PROPOSED FUEL STATION & CAR SERVICE

LOCATION: LOTS 36, CNR DIXON ROAD & EVINRUDE BEND, ROCKINGHAM

LOT 36 DIXON ROAD, ROCKINGHAM
RESPONSE TO REQUEST FOR INFORMATION
PROPOSED SERVICE STATION DEVELOPMENT – DAP FORM 1 APPLICATION

FIGURE 1: Copy of the Planning Proposal

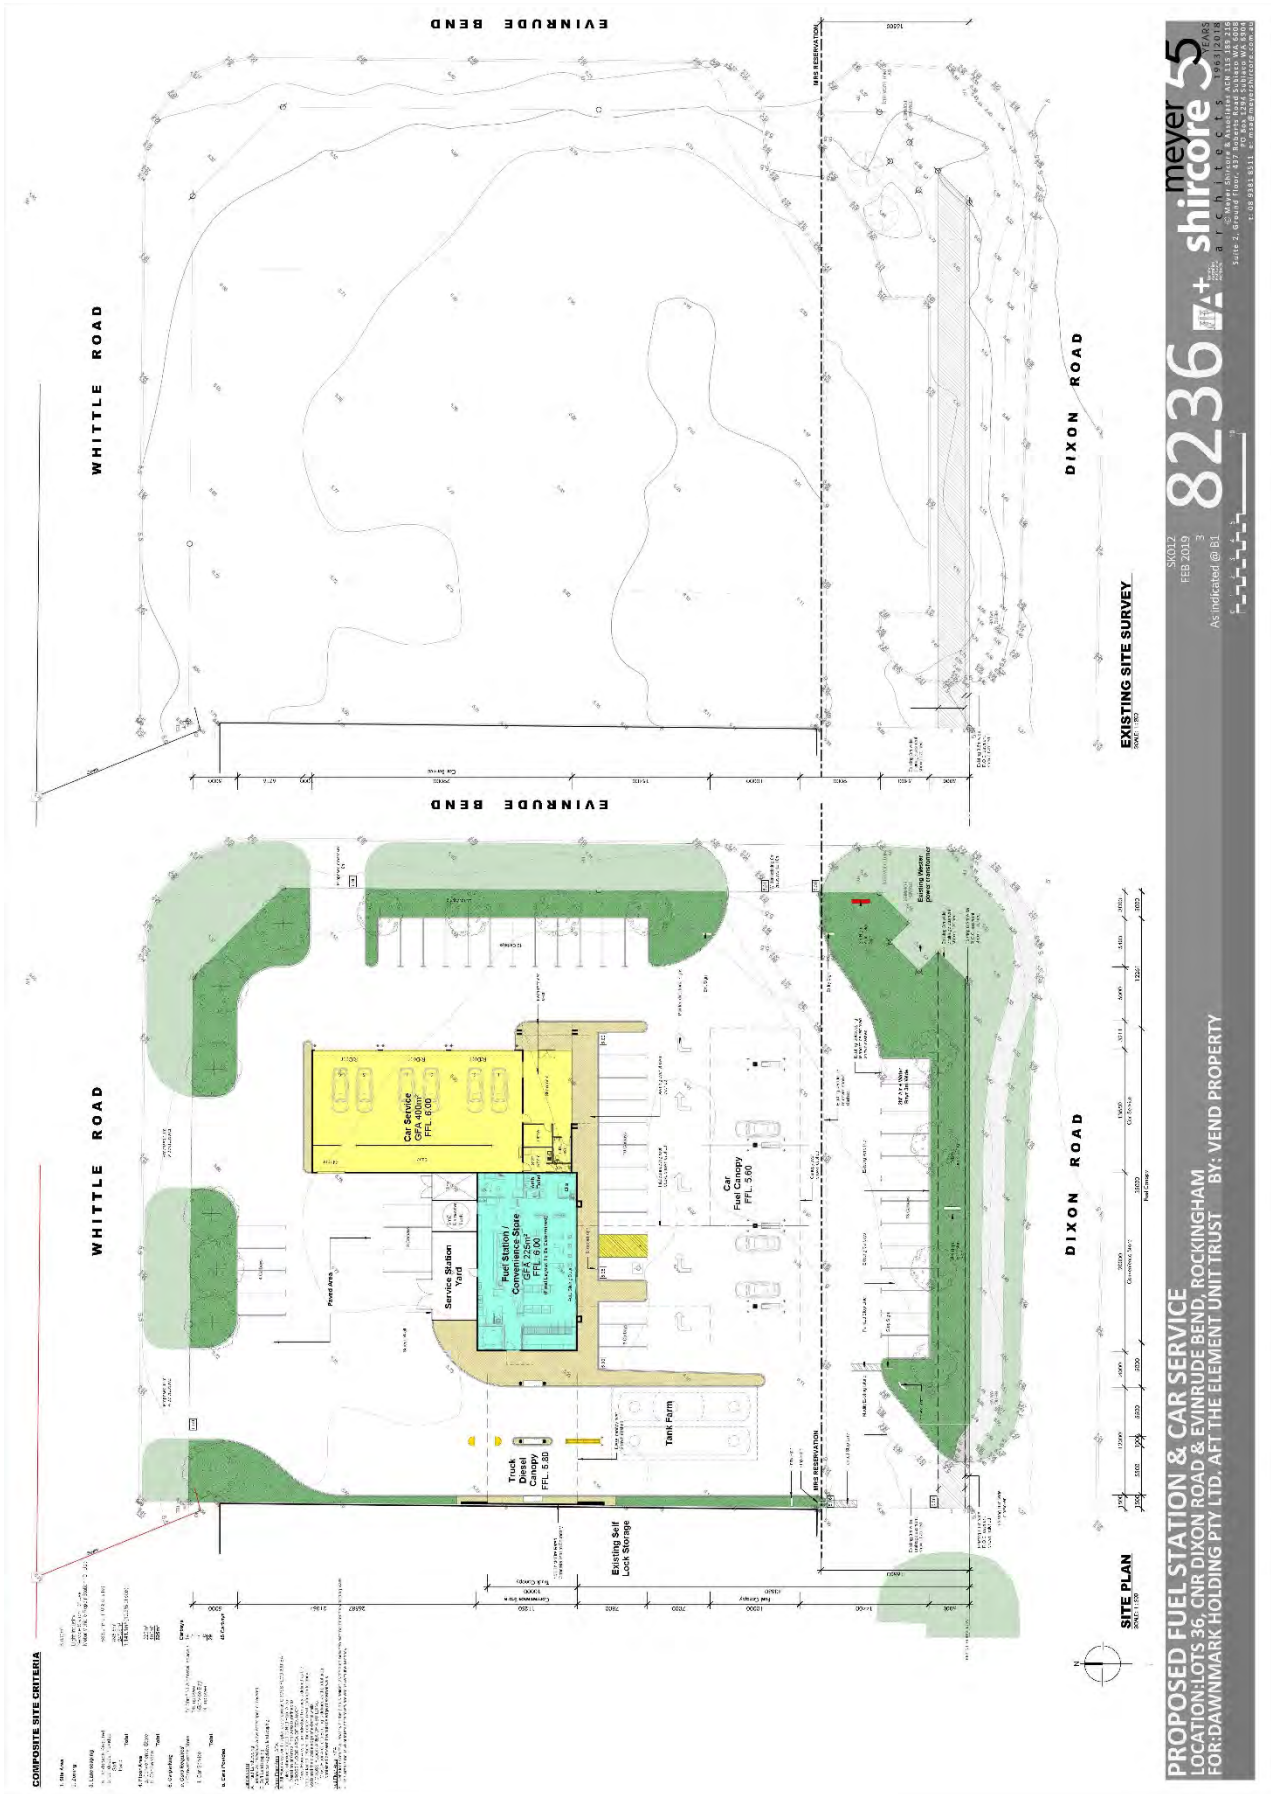
SERVICING AUTHORITIES SCHEDULE OF SUBMISSIONS				
Name	Address	Comment		
No.3 – cont...		Development Footprint	The BAL Assessment within the BMP has not considered the location of the fuel canopy. Figure 1 shows a truck and car fuel canopy which appear to adjoin the fuel station convenience store. The BAL ratings should be calculated from the edge of the fuel canopy.	Modification required.

2. Policy Measure 6.5 c) Compliance with the Bushfire Protection Criteria		
		Element	Assessment	Action
		Location and Siting & Design	A1.1 and A2.1 – not demonstrated The BAL ratings cannot be validated, as the BAL assessment has excluded the fuel canopy.	Modification/clarification required.
		<u>Recommendation – not supported modifications required</u> It is critical that the bushfire management measures within the BMP are refined, to ensure they are accurate and can be implemented to reduce the vulnerability of the development to bushfire. The proposed development is not supported for the following reasons: 1. The development design has not demonstrated compliance to Element 1: Location and Element 2: Siting and Design. As this planning decision is to be made by a Joint Development Assessment Panel please forward notification of the decision to DFES for our records. If you require further information, please contact me on telephone number 6551 4075.
